Belt Drive Walk-Behind Snap-Ring Replacement

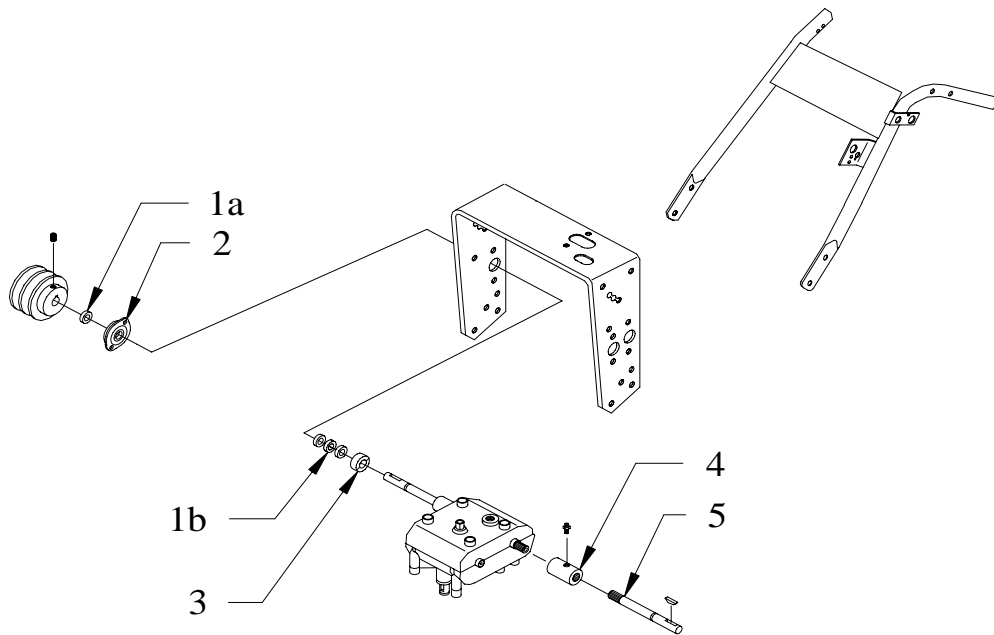
For machines that are experiencing re-occurring snap-ring failures, an alternative repair may be performed. The 5/8" snap-ring (part # 108508) may be substituted with three transmission shaft spacers (part # 363087) and one 5/8" clamp collar (part # 363339). The 5/8" clamp collar and transmission shaft spacers must all be installed snug against the inside of the flange bearing.
